Design Review Report – Item 1

Local government:	City of Stirling	
Item no.:	Item 1 - PDA24/0024 – 118 Flora Terrace, North Beach - Pre Development Application – Multiple Dwelling	
Acting Chairperson:	Philip Gresley	
Panel members:	Munira Mackay Tony Blackwell David Karotkin	
Local government officers:	Peter Prendergast Karina Bowater Cameron Howell Simone Palmer	Service Lead Planning Coordinator Planning Senior Planning Officer DRP Support Officer
Observers	Shaun Wheatland Gareth Glanville Olivia Abbonizio	Senior Planning Officer Coordinator City Future Projects Senior Strategic Planning Officer, City Future
Date:	9 May 2024	Time: 2pm
Venue:	City of Stirling – Challenger Room

GROUND

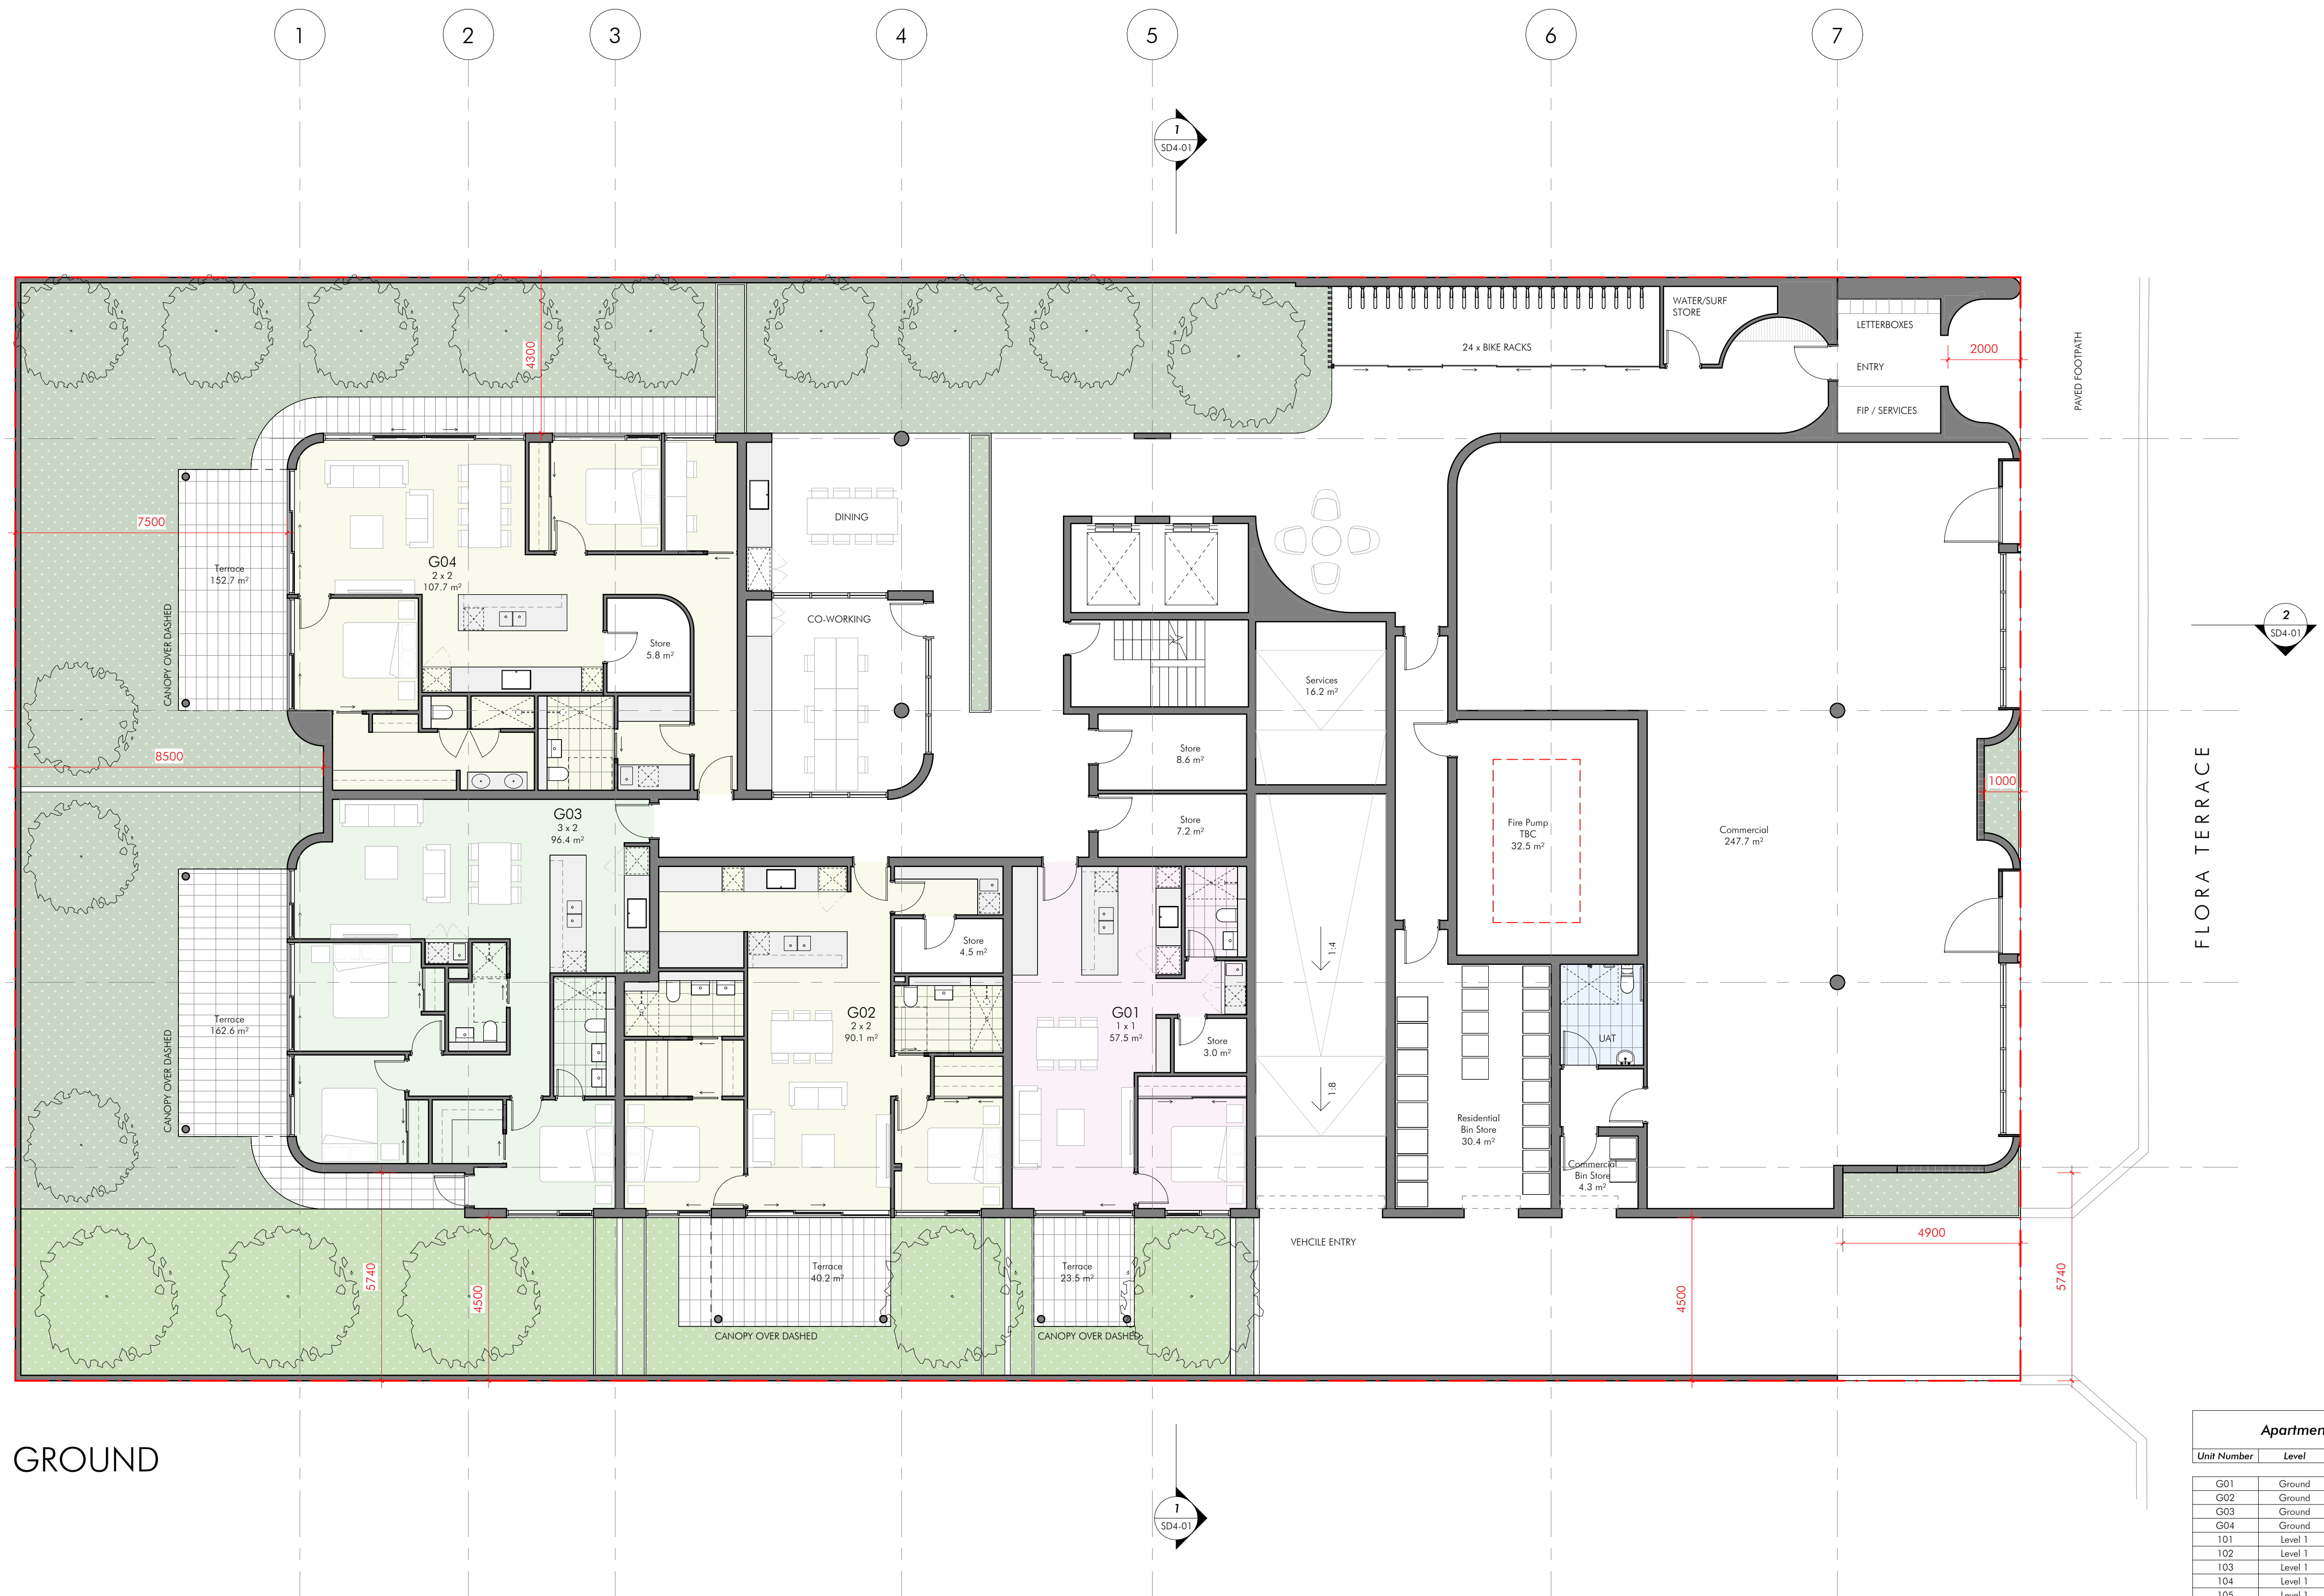
requirements such as overshadowing to R20 and passive solar design requirements. The maximum allowable development envelope does not automatically accommodate good design or satisfy the 10 design principles of SPP7.0.		amenity, and safety. The proponent is encouraged to re-consider how this will be improved noting that any increases to the scale and dimensions of the envelope will not likely be supported.	
4b. The Panel queried the ground floor, floor to ceiling height to accommodate the intended use.		4d. There was concern expressed by the Panel around the functionality of the communal entry area. Further information is requested to provide clarity and resolution. 4f. It was noted by the Panel the bike store is in an awkward location and there could be potential conflict between the bikes and pedestrians. There is opportunity to relocate this and improve functionality. 4g. It was mentioned by the Panel the depth of some apartments (vs ceiling height) may be problematic and requires resolution. 4j. The Panel stated there are logistic issues associated with waste disposal. The current process of having to go through the lobby is not a good outcome. The moving of the bins to the street in the narrow driveway also requires further explanation. 4k. The Panel expressed concern around the width of the driveway access to the ground floor basement. It is currently 4.5m with a blind corner and a steep ramp. Further information is sought including swept path analysis.

Panel encourages ongoing coordination and collaboration between landscape architect and the architect.	
		8a. The Panel expressed concern around the width of the driveway access to the ground floor basement. It is currently 4.5m (less than a 2-way driveway) with a blind corner and a steep ramp which could pose a safety issue. Further clarification is required as to how this is being managed. 8b. Comment was made the manoeuvrability in the carpark has been impacted by yield and looks very tight. Swept paths should be provided to demonstrate how this will work.	
9a. It was stated by the Panel the community benefit for this proposal is important if the Applicant is seeking discretions for the height of the building. 9b. The community benefit for the height discretions should be communicated and dialogue and justification around what is being given back to the Community is imperative to gain support for additional height.		9a. This design principle is supported by the Panel. 9e. It was noted by the Panel clarification on the size of the communal open space would be beneficial.
